ADDENDUM

No. 03 Date: 9/11/2024
Project No. 0020711.01 Attention: Leonard D'Souza
Project Name: Princess Margaret Cancer Centre
Stem Cell Transplant 2, MHC, MHDU, DSC
Address: University Health Network
610 University Avenue
Toronto ON

This Addendum forms a part of the Bidding and Contract Documents and modifies the original issued Bidding Documents (dated August 13, 2024) for the above titled project, as indicated below, and is hereby incorporated into the Contract Documents as part thereof.

PT-001

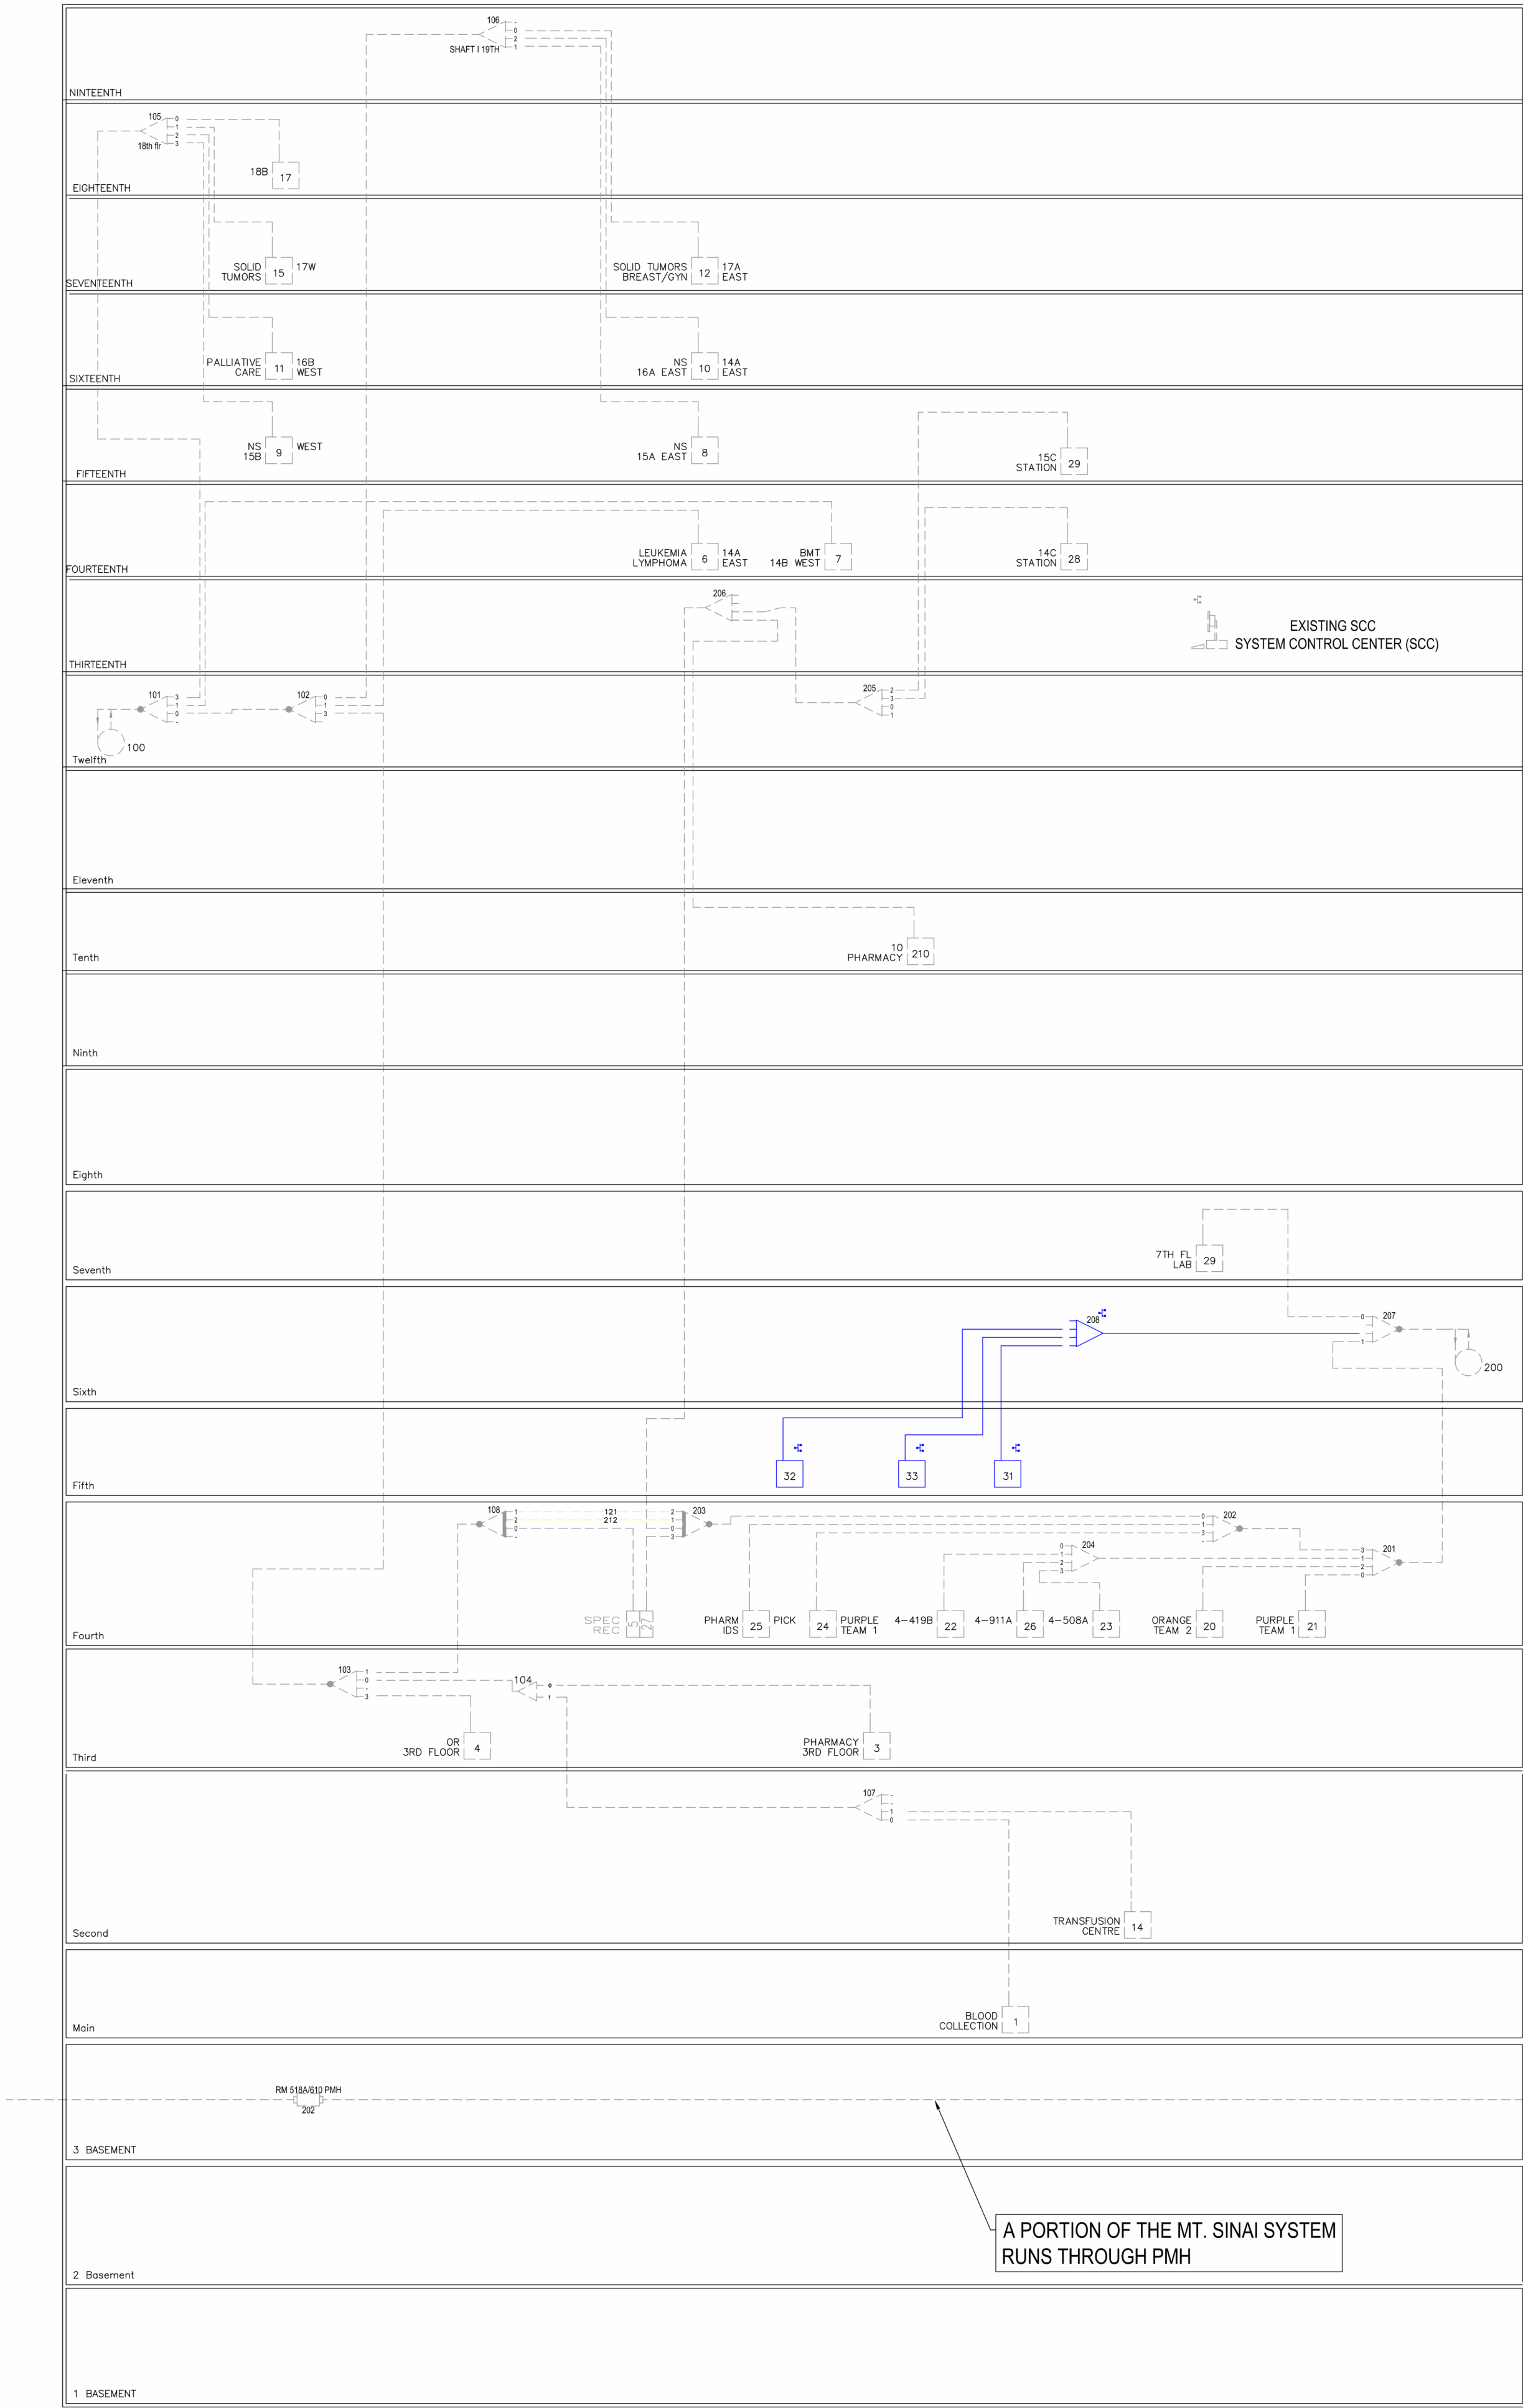
1. **Drawing PT-001 – PNEUMATIC TUBE SYSTEM – PLAN SYMBOLS & NOTES**
 - Clarification of Mechanical Contractor's scope of work, as indicated
2. **Drawing PT-100 – PNEUMATIC TUBE SYSTEM – MECHANICAL RISER DIAGRAM**

PT-100

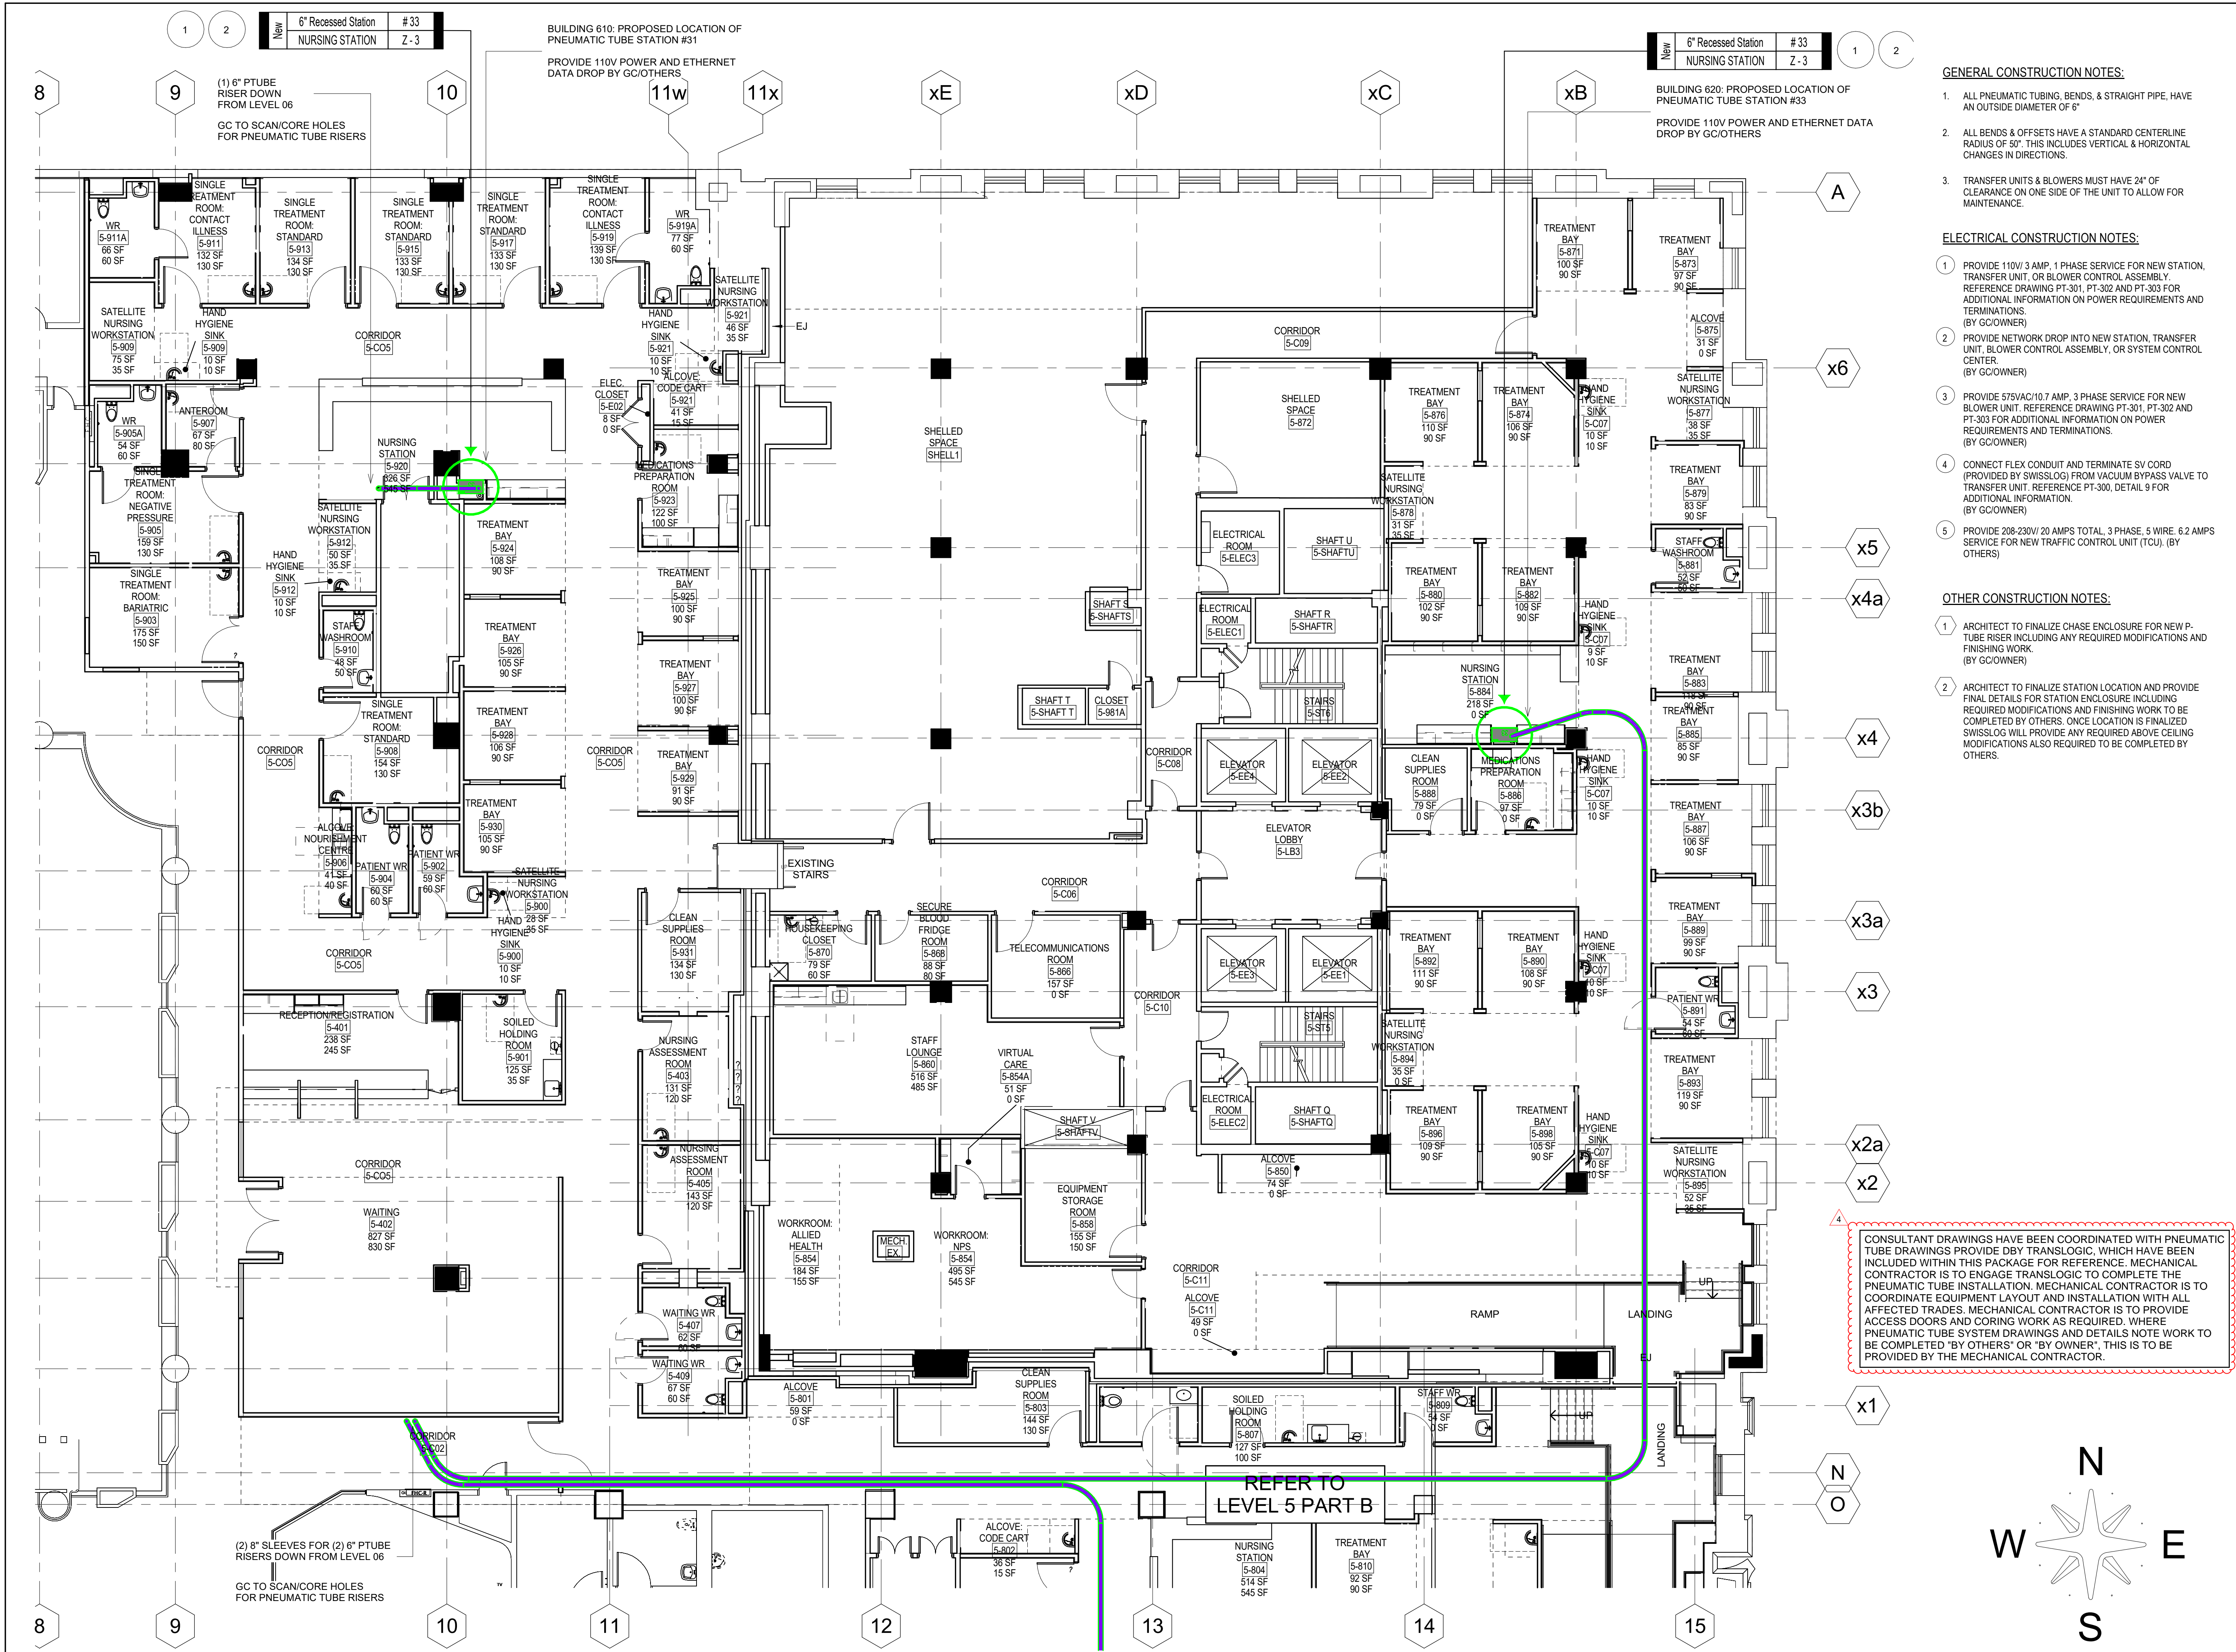
- Clarification of Mechanical Contractor's scope of work, as indicated.
3. **Drawing PT-205A – PNEUMATIC TUBE SYSTEM - LEVEL 05 - FLOOR PLAN A**
 - Clarification of Mechanical Contractor's scope of work, as indicated.

PT-205B

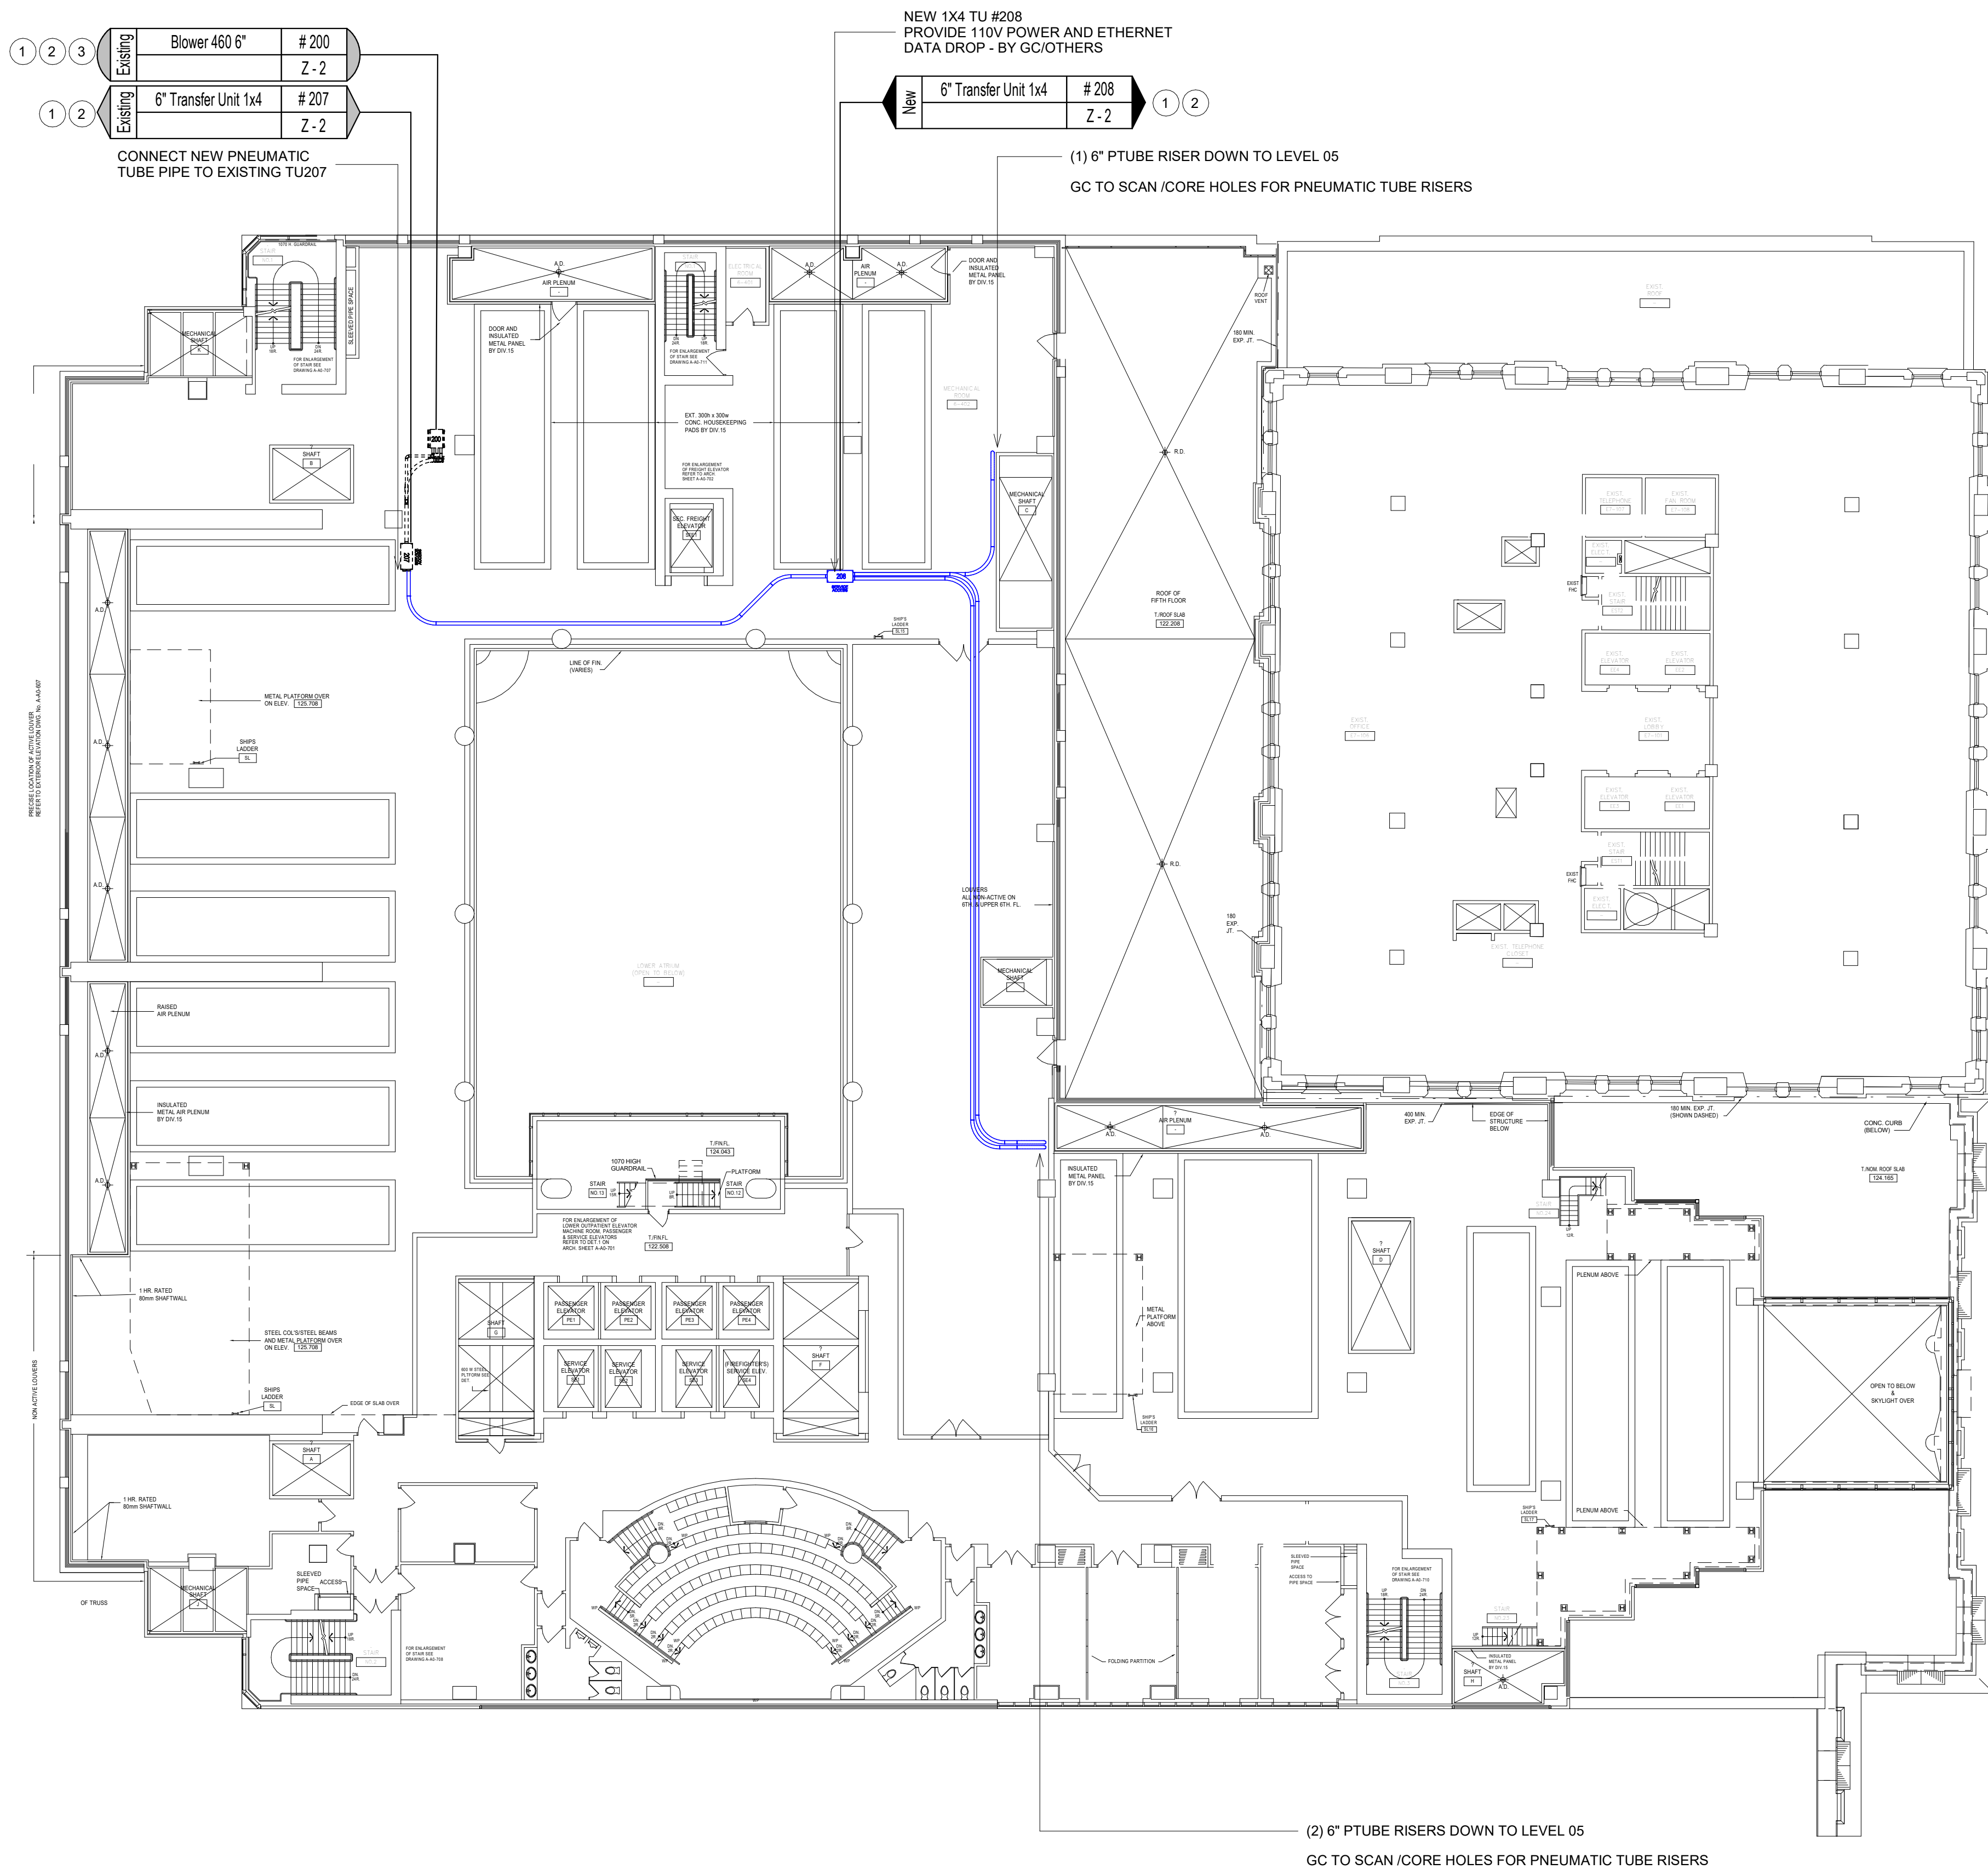
4. **Drawing PT-205B – PNEUMATIC TUBE SYSTEM - LEVEL 05 - FLOOR PLAN B**
 - Revision to pneumatic tube routing, as indicated.
 - Clarification of Mechanical Contractor's scope of work, as indicated.
